Land and Lakes Co.

WEZ 19780303 N
Will Co.
Lemont/Land and Lakes

Land and Lakes Company would like to take this opportunity to present its proposal and to discuss the Agency's conclusions as stated in the letter of June 26, regarding the ground water monitoring program at the Lemont landfill facility.

Boring No. 1-A-Revised

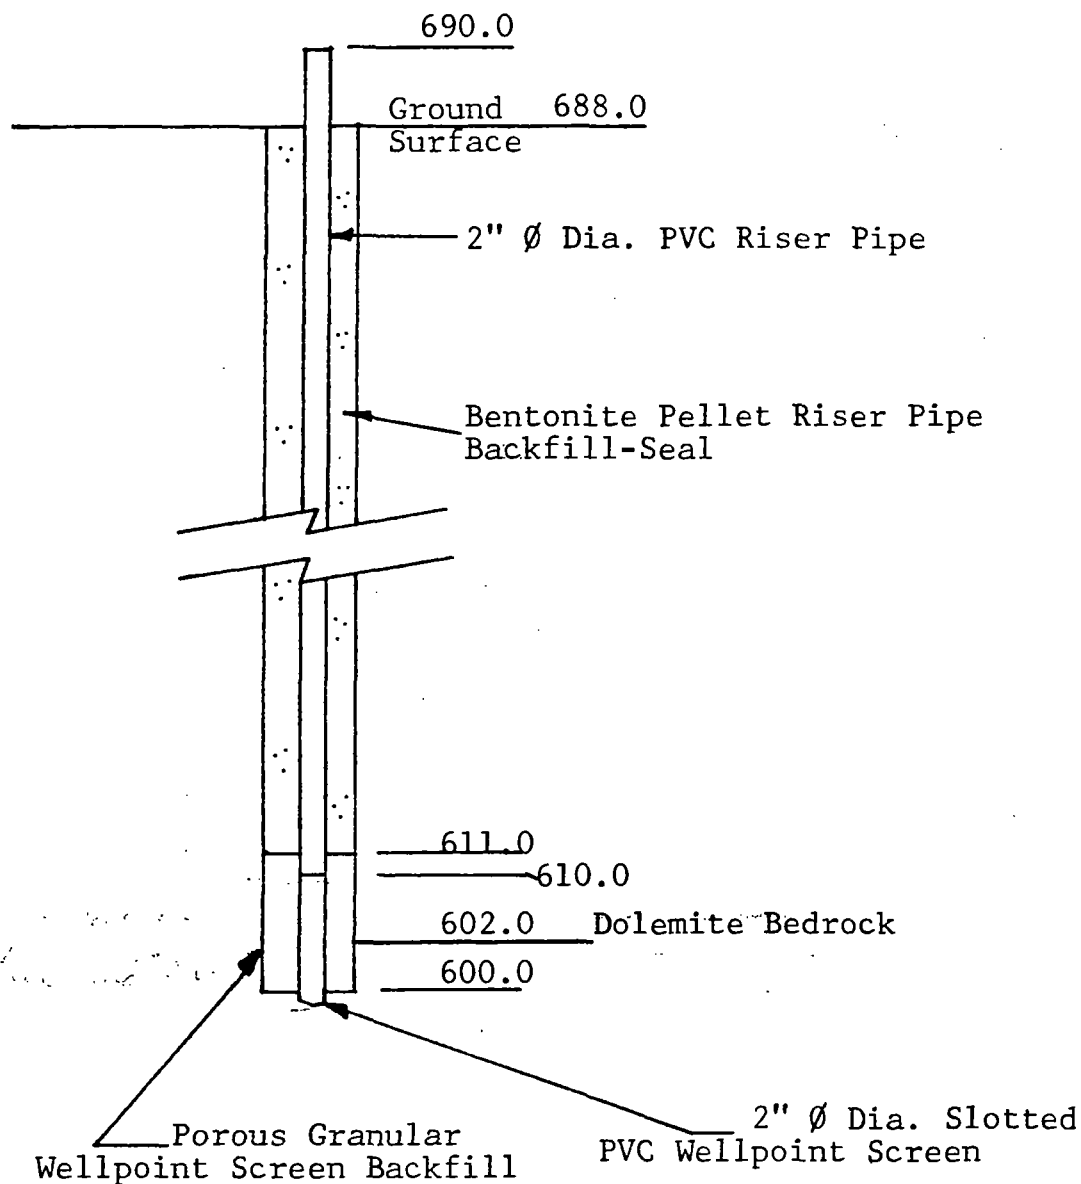
4. It is the intention of Land and Lakes Company to install new monitoring wells in place of those located in future fill areas: The proposed design of these wells is included with this report.

NOTE: Location of this wellpoint will be 200' east and 25' south of the Northwest Property Corner.

Boring No. 8-Revised

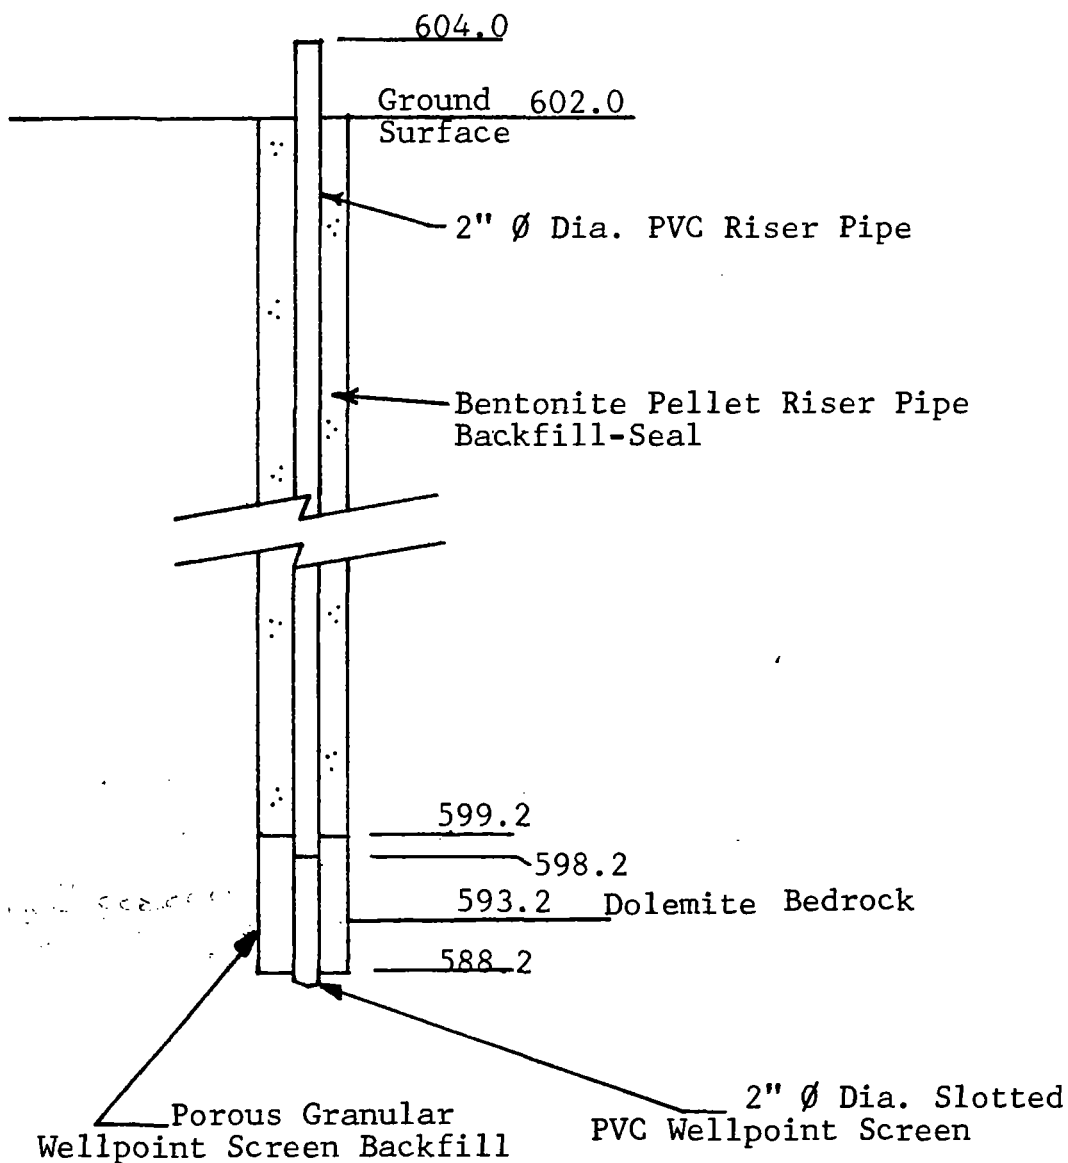
NOTE: Location of this wellpoint will be 50' south
of the existing well.
